PLANNED REZONING OVERLAY (PRO) PLAN ELM CREEK BY TOLL BROTHERS

PLANNING REVIEW

PRO Concept Plan: Formal Submittal

Rezoning Request from OST Office Service Technology to Low-Density Multiple Family RM-1 with a Planned Rezoning Overlay

L-1

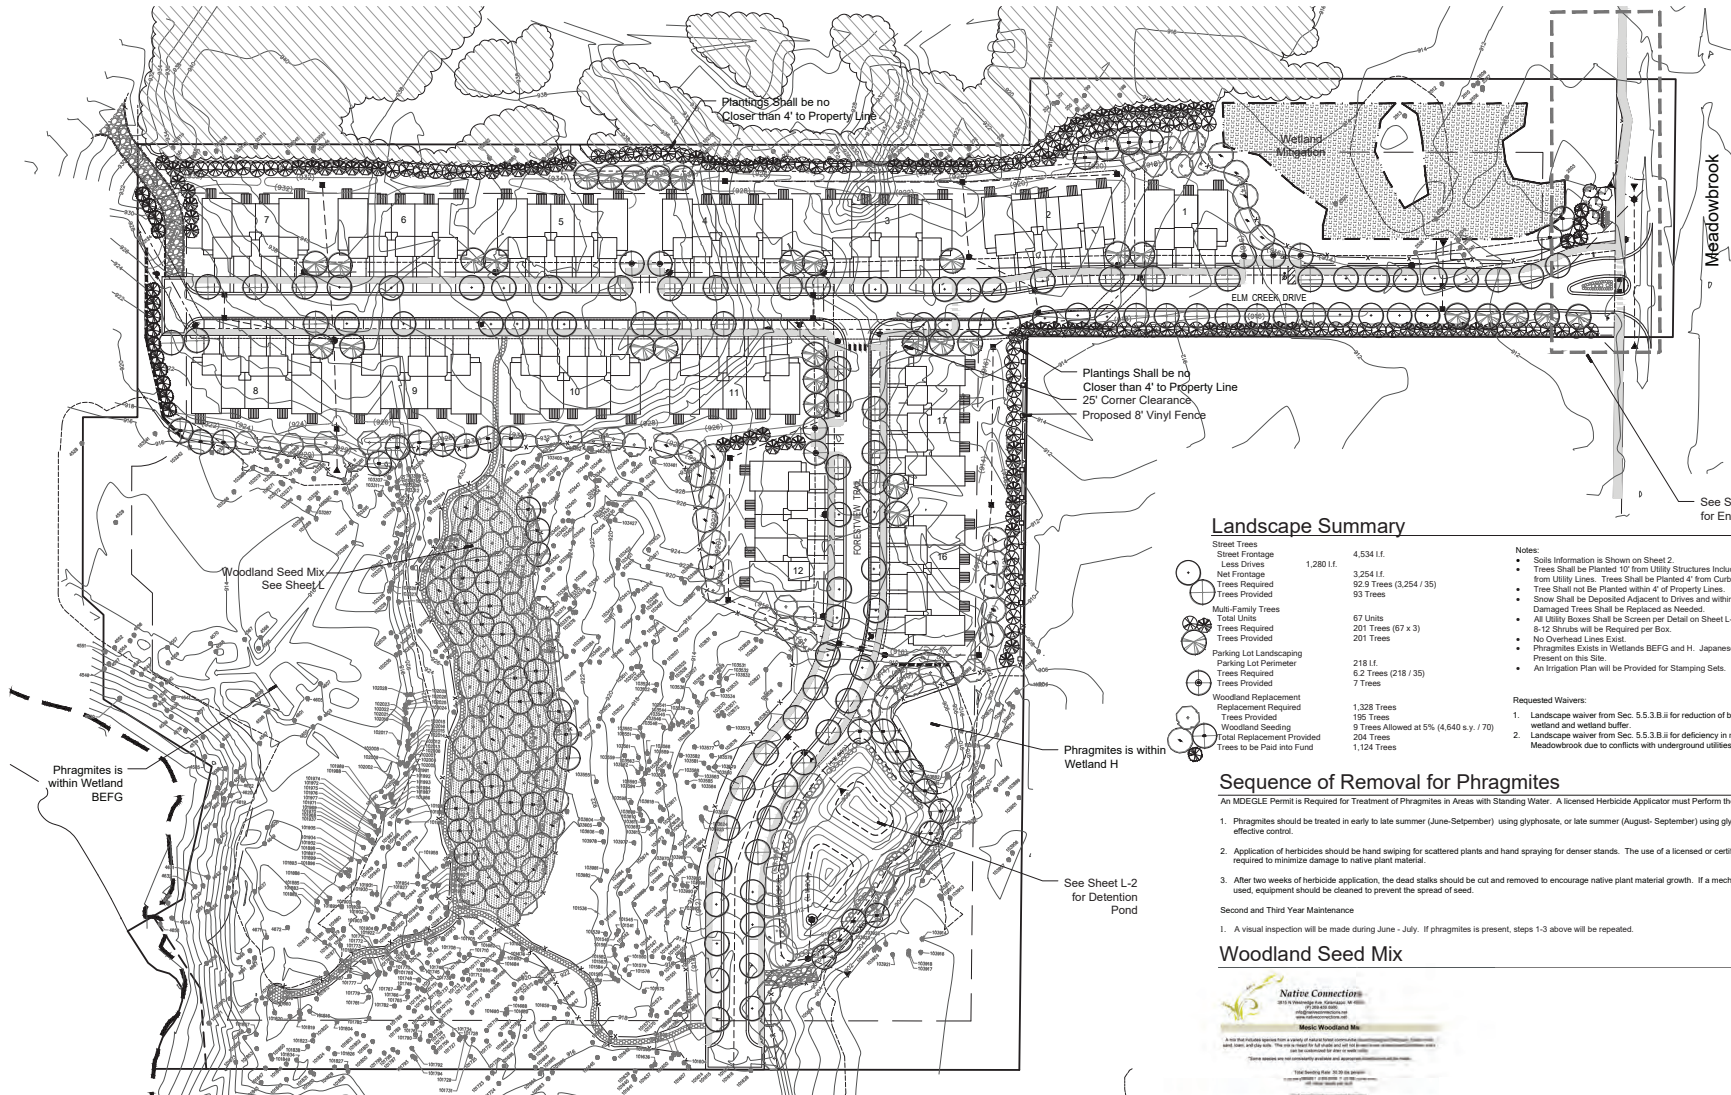
- a. DRG requested that the cost to stake, install, and remove the tree protection fencing be added to Sheet L-3 in order to calculate woodland fence inspection fees. Prior to final site plan approval this should be added to either Sheet L-1 or L-3.
